DUKE POWER COMPANY
OCONEE 3 CYCLE 13
CORE OPERATING LIMITS REPORT
REVISION 2
MAY 16, 1991

Subject: Oconee Nuclear Station
03C13 Core Operating Limits Report
File: OS-228.24

Oconee Nuclear Station
Unit 3 Cycle 13
Core Operating Limits Report
Revision 2
Revision Log

Figure 1.1

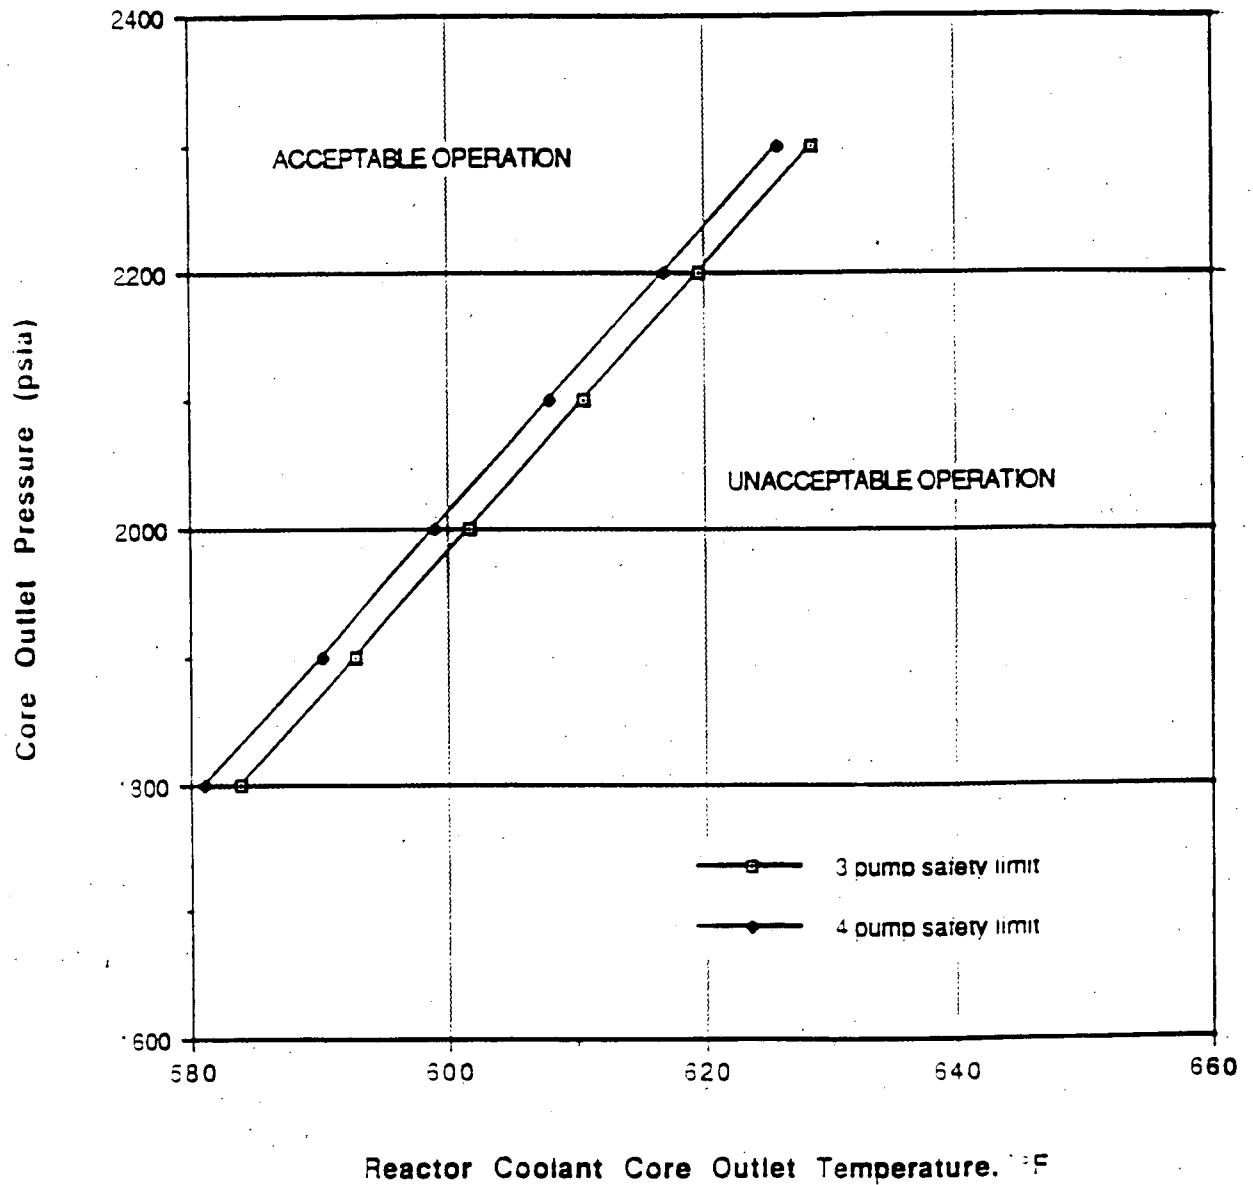
Reference 1 verifies that the RPS safety limit and trip setpoints currently in the Technical Specifications are valid for 03C13. Reference 2 justifies a change in the variable low pressure safety limit. Thus, these references provide the basis for the figures that have been added to the COLR.
